MIDLAND #1

MONTHLY NONCONFORMANCE REPORT FOR 9/78.

LOG OF NONCONFORMANCE REPORTS

Midland

FIG A (TYP 1 + 2 POS B)

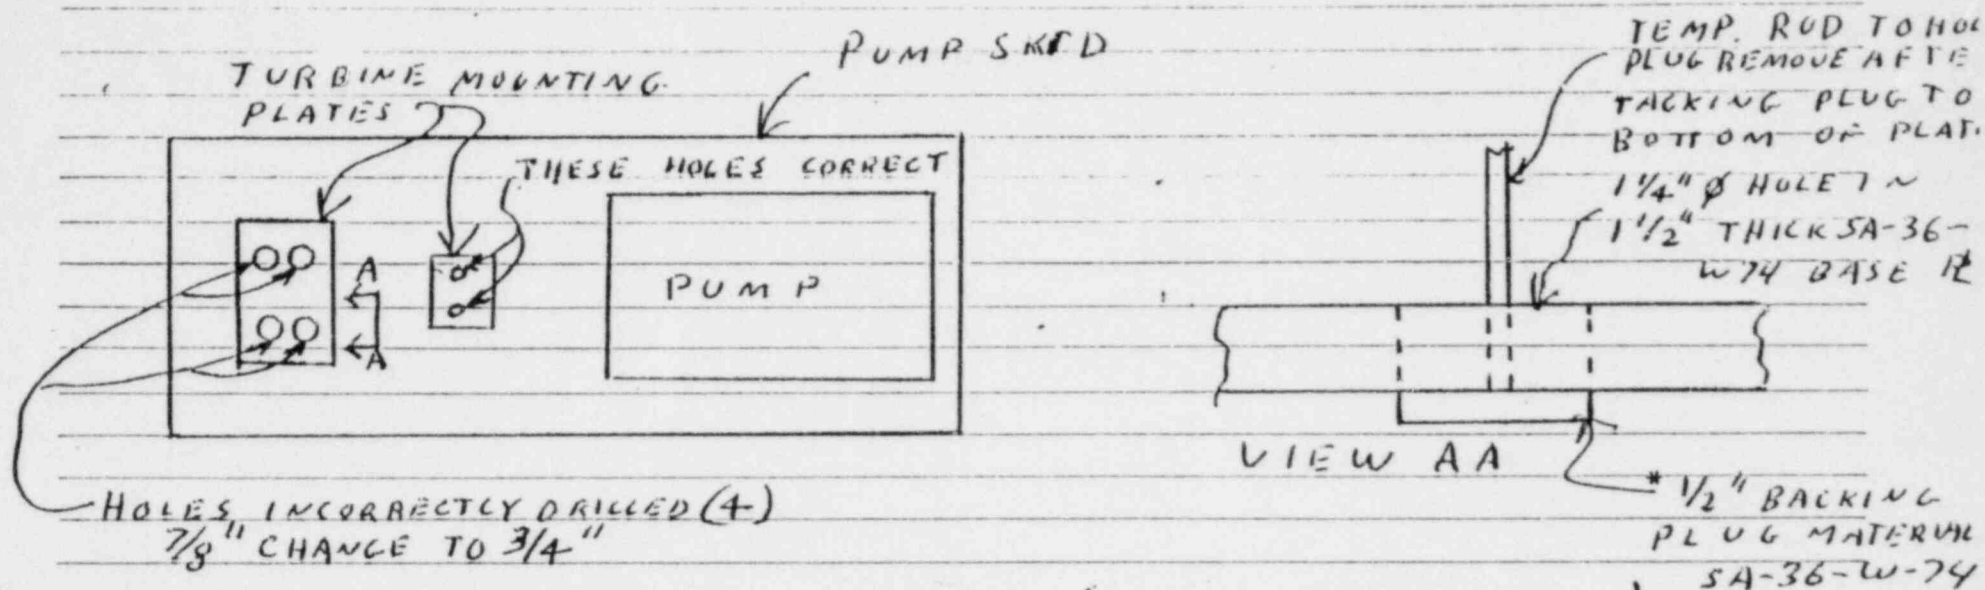
1. PROJECT NAME MIDLAND		JOB NO. 7220		19. NO. 1560	20. PAGE 1 OF 2	
2. UNIT(S) 1 & 2	3. DRAWING/PART NO. 1P-05B & 2P-05B	REV N/A	4. ITEM DESCRIPTION STEAM DRIVEN AUX. FEEDWATER PUMPS	5. ITEM LOCATION AUX. BLD INSTALLED EL. 58

22. ☒ Field Engineering Disposition ☒ Field Engineering Recommended Disposition to Project Engineering Disposition Requested By: 10-4-78						
Correct oversize holes as follows: a) Check mounting base for flatness b) Drill out 4 holes presently tapped to 7/8" to 1 1/4" c) Weld backing plates to bottom of holes per Fig. A. d) Fill in holes with weld metal use weld procedure Pl-A-LH e) Grind top of holes flat f) Recheck mounting base for flatness g) retap holes per installation manual.

* Note: 1/2" backing plug will be permanent part of repair. Q.C. must be assured it is in fact SA-36-W-74 material.

OUR RECOMMENDATION IS TO DRILL THE FOUR (4) OVERSIZE
HOLES TO APPROXIMATELY 1-1/4"; WELD COMPLETELY WITH
APPROVED PROCEDURES - QUALIFIED WELDERS - AND
APPROPRIATE WELD METAL (A36-W74); THEN DRILL AND TAP TO
CORRECT 3/4" SIZE. APPROPRIATE NDE TO ACCOMMODATE YOUR SITE
NEEDS SHOULD BE EMPLOYED.

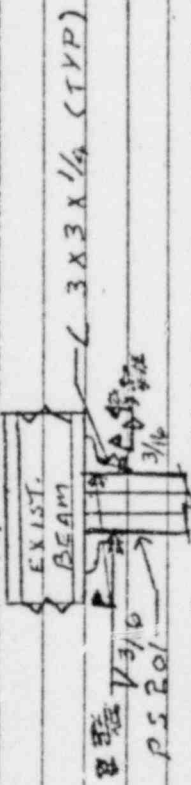
Block 22 Continued:

beam as shown:

Because we were unable to weld the top of the strut we welded inside vertically as follows:

Procedure Procedure was set for this weld by G. L. Strong to R. L. Harrison Memo 12/16/77 with resulting REM E-182 dated 12-21-77 (copy attached) Field Civil Engineering also concurs with welds as installed.

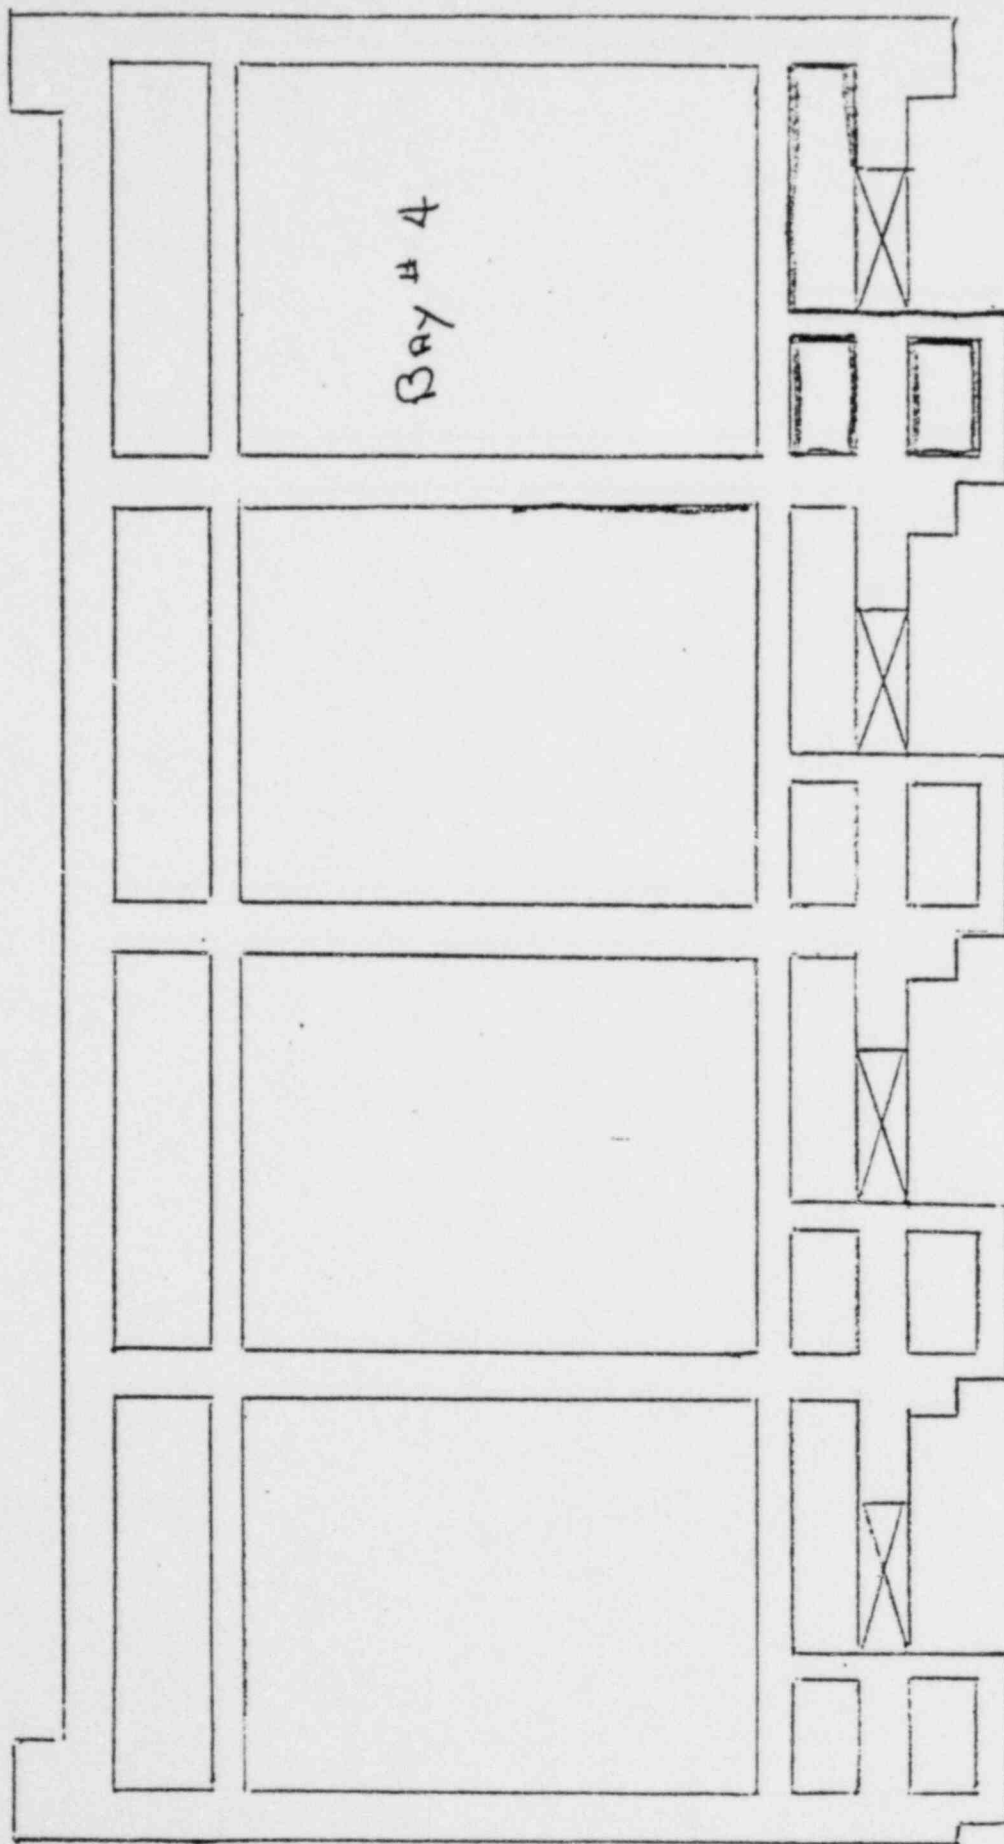
Block #22 continued:

cured with liquid membrane curing compound upon removal of forms.

* FORMS REMOVED AFTER 24 HRS

VIEW AA

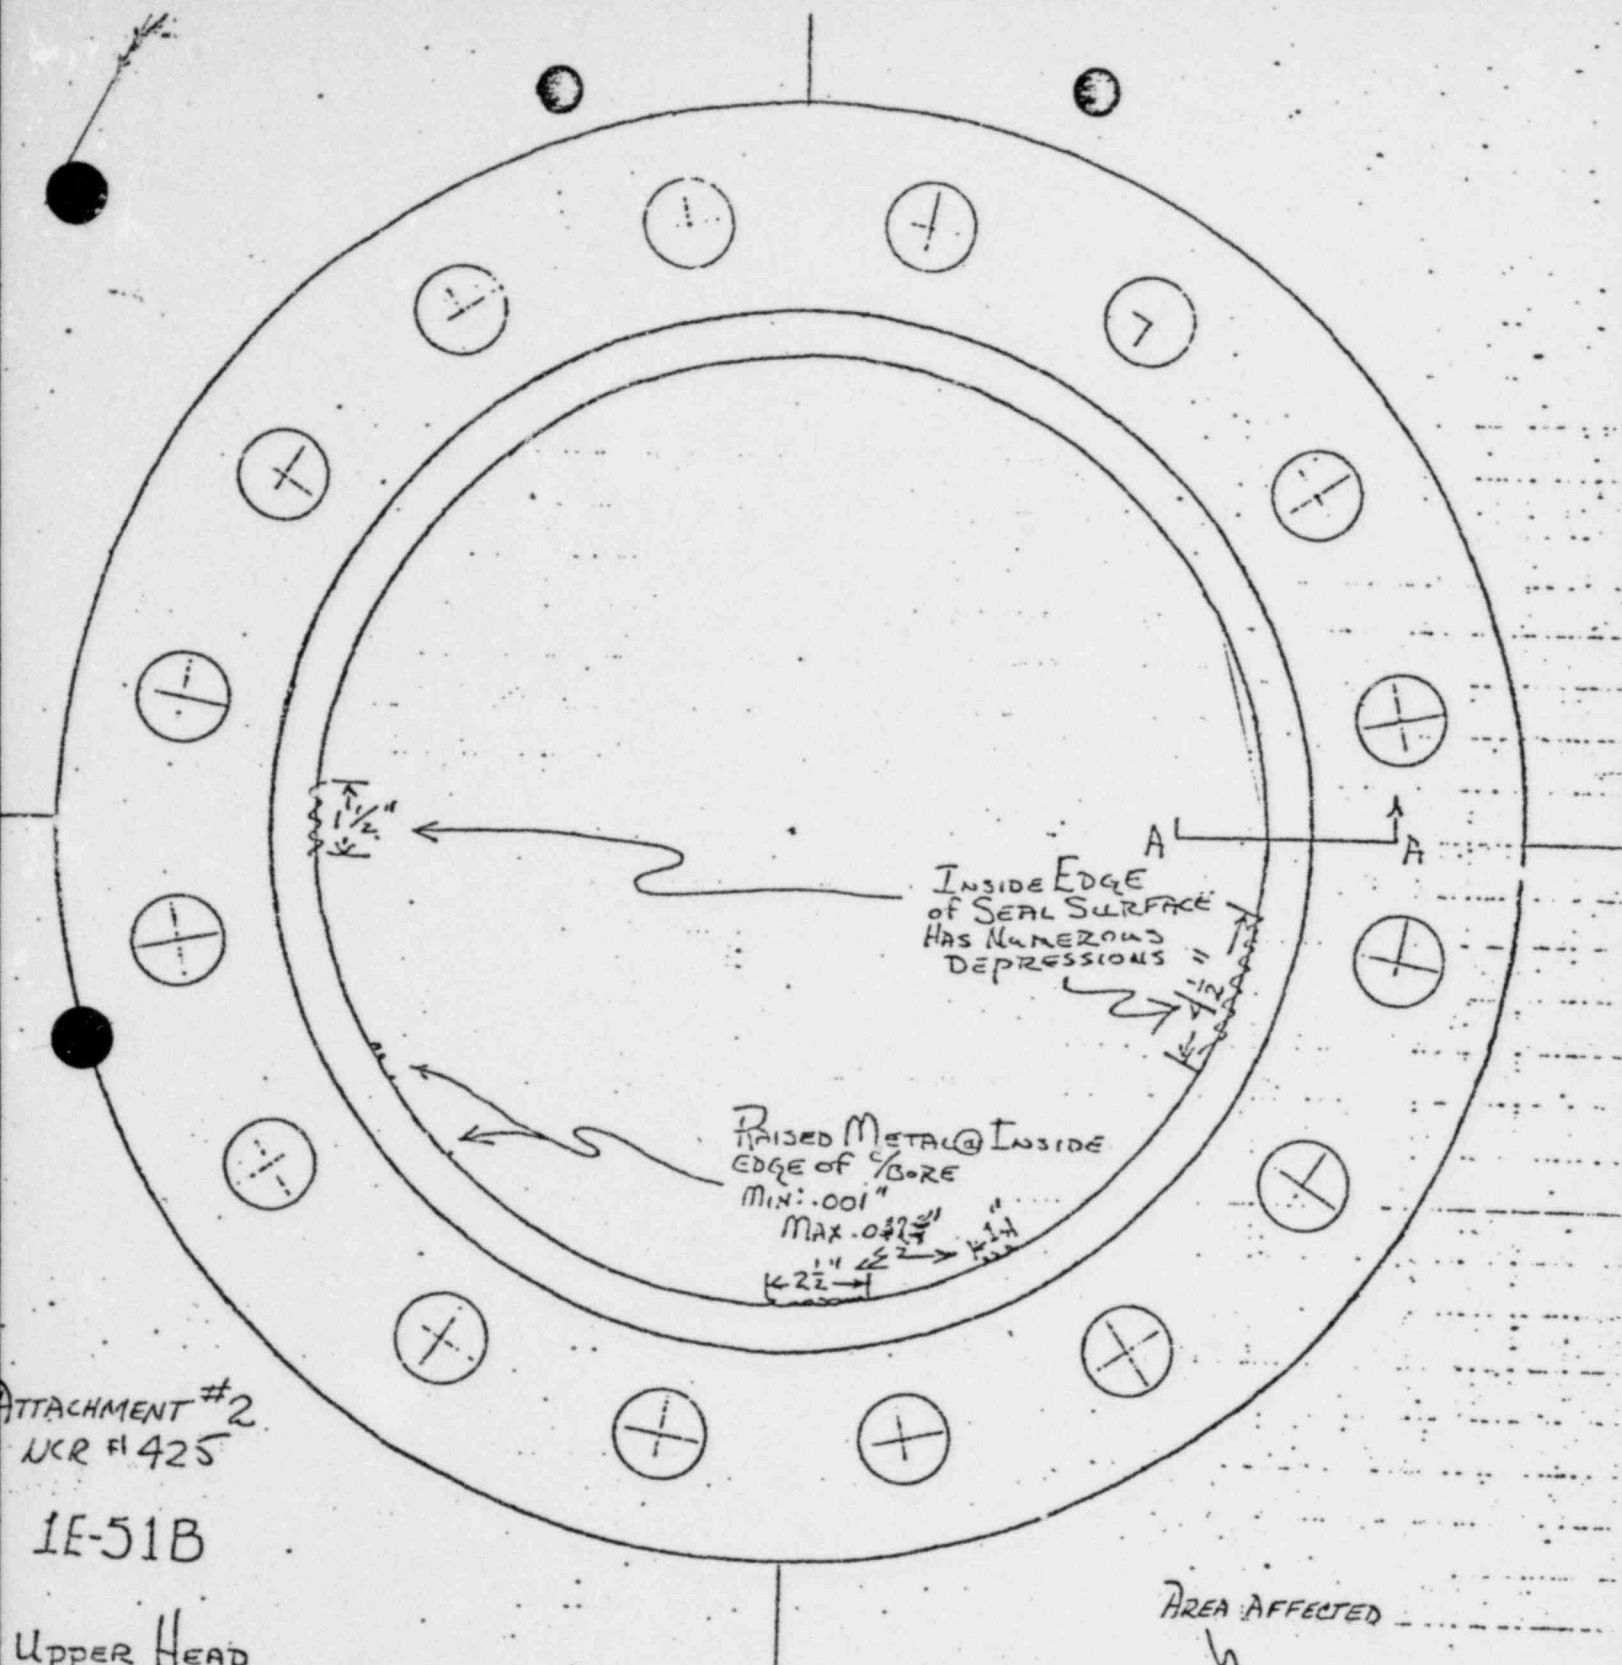
E-51A
UPPER HEAD
WAY COVER
-8-78
